# Technical Service Bulletin

SUBJECT:			No: <b>TSB-20-55-001</b>
<b>REDUCED CABIN HEATER PERFORMANCE DURING IDLE AND LOW VEHICLE SPEED</b>			DATE: <b>December 2020</b>
			MODEL: <b>2018-2020 Eclipse Cross</b>
<b>CIRCULATE TO:</b>	<input type="checkbox"/> GENERAL MANAGER	<input checked="" type="checkbox"/> PARTS MANAGER	<input checked="" type="checkbox"/> TECHNICIAN
<input checked="" type="checkbox"/> SERVICE ADVISOR	<input checked="" type="checkbox"/> SERVICE MANAGER	<input checked="" type="checkbox"/> WARRANTY PROCESSOR	<input type="checkbox"/> SALES MANAGER

## ECU REPROGRAMMING CHART

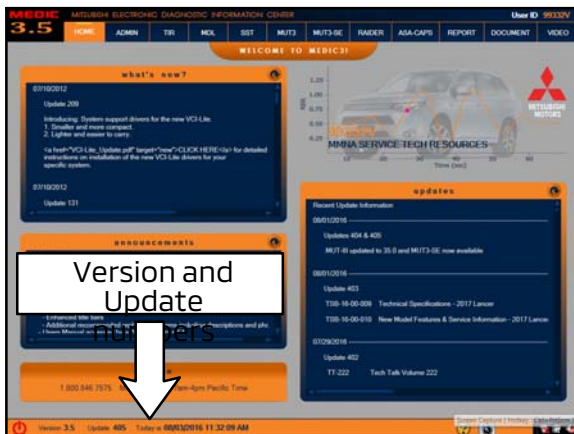
Customers may notice a reduction in heater output temperature while idling or during low vehicle speeds. When ambient temperatures are extremely low, the coolant temperature may remain low, affecting heater performance. Both issues may be caused by improper programming of the ECU.

This TSB instructs dealers to reprogram the A/C ECU with updated software to address the issue upon customer complaint basis.

Model	ECU Part Number	Data Number	Software Part Number	
			Previous	New
18MY Eclipse Cross	1860D116	1862D147	1860D11605/B42529	1860D11605/B42531
			1860D11603/B42528	
			1860D11602/B42527	
			1860D11601/B42526	
			1860D11600/B42525	
19MY Eclipse Cross	1860D402	1862D148	1860D40202/B49806	1860D40203/B49808
			1860D40201/B49805	
			1860D40200/B49804	
20MY Eclipse Cross	1860D573	1862D149	1860D57300/B56105	1860D57301/B56107
